Proposed Residential Development,
Dalguise House, Monkstown Road,
Co. Dublin

Quality Audit

Document Ref:	P22-148-UQA-GEN-RP-001
----------------------	-------------------------------

Location: Shared Carriageway at Purbeck

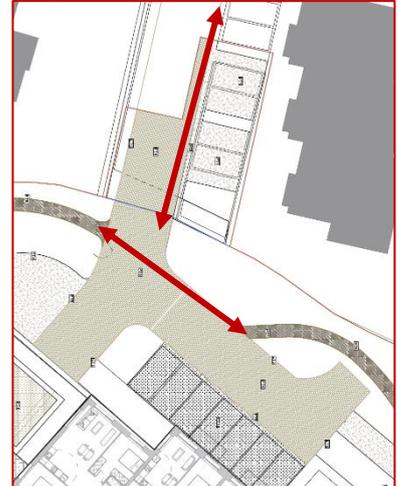
Summary: Lengthy pedestrian routes through busy area of shared carriageway.

It is unclear where the existing footpath on Purbeck will tie-in with the internal development footpaths. It appears that the existing footpath will connect into a shared carriageway, at a location where 80% of vehicular traffic entering/exiting the development will also be using the carriageway.

In addition, proposed loose bark surfaced paths connect with this shared carriageway in the vicinity of the proposed crèche, and in order to continue along the path of pedestrians will be required to travel within the shared carriageway over a longer than necessary distance.

Lengthy pedestrian routes through a relatively busy section of carriageway would lead to an increased risk of vehicle/pedestrian collisions.

The existing footpath provision along Purbeck should be extended into the proposed development, with appropriate crossings on likely crossing desire lines. The layout of the loose bark surfaced paths should be amended in order to provide a crossing which is as short as practicable.

On the approaches to the interface with the carriageway, a section of the loose bark surfaced paths should be paved and tactile paving provided to warn pedestrians of the upcoming crossing.

3.5.1	Yes	Yes		
3.5.2	Yes	Yes		
3.5.3	Yes	Yes	The access road has been widened in certain areas in order to allow for passing bays on the way in. This access road is a shared space for pedestrians and cyclists and there will be minimal traffic on this route. The gateway will be widened and a passing area provided just inside.

Location: General Problem – Loose Bark Surfaced Paths

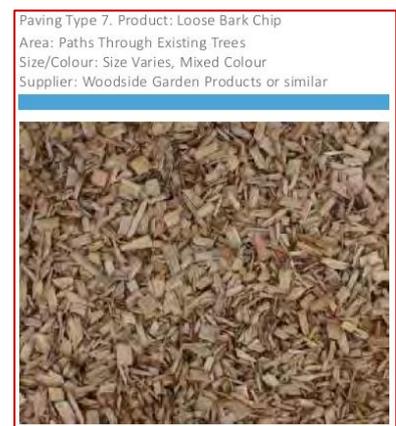
Summary: Unbound road surface may represent slip and trip hazard

It is proposed to provide unbound “Loose Bark Chip” path material for some of the internal footpaths. The unbound material may deteriorate over time, creating unstable or uneven ground, leading to slips, trips or falls.

It is also unclear if unbound surfacing is proposed on the steps along the unbound paths. Loose material on the steps may exacerbate the risk of slips, trips or falls.

During the design development the proposed path surface and step surfaces should be designed so as not to present a slip or trip hazard.

3.5.13	Yes	Yes		
3.5.14	Yes	Yes		
3.5.15	Yes	Yes		
3.5.16	Yes	Yes

4.2 Building Accesses

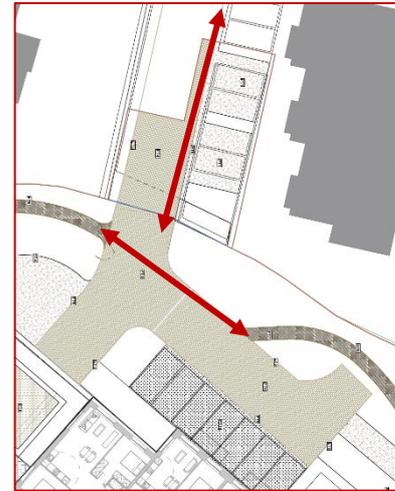
Accessibility issues relating to Building Accesses have been discussed in Section 3.5.5.
